Zhone Technologies, Inc.

Field Alert Bulletin
FAB-200301
IMACS Interface Card Failure (892260, 892360 and 892460)

Zhone IMACS Interface Card, 892360 Revision B1

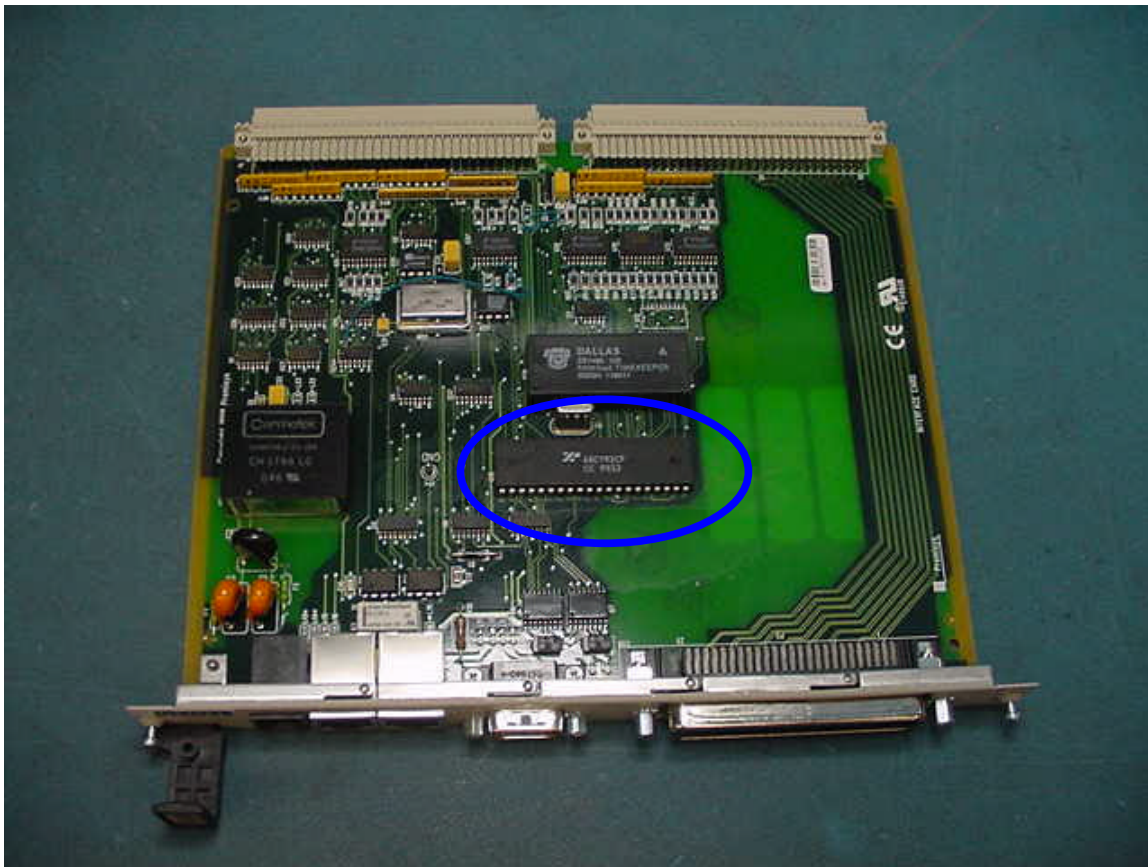
If you have experienced the condition where corrupted alarm string characters are being detected coming from the COMP port of the IMACS interface cards (892260, 892360 or 892460), check to see if your Interface card has the Exar DUART component (see the background information below). If it does, contact your equipment provider or Zhone Technologies, Inc., (at 1-877-946-6320, prompt #3) to have your Interface card reworked or replaced.

In November 2001, the DUART chip, manufactured by Philips, was replaced with an Exar DUART because of a die size change in the Philips DUART which caused it to be incompatible with the access timing design of the Interface cards. This change was made for all IMACS Interface cards using a DUART (892060, 892160, 892260, 892360 and 892460).

The photos below show the location of the DUART chip and the details of the two manufacturers, Philips and Exar.

Rework on the Interface card consists of removing the Exar DUART and replacing it with a Philips DUART with a date code that precedes the die change made by the manufacturer, as discussed in the background information below. This will change the revision level of these Interface cards as follows:

892260 Rev. A1 will go to A2
892360 Rev. B1 will go to B2
892460 Rev. B0 will go to B1
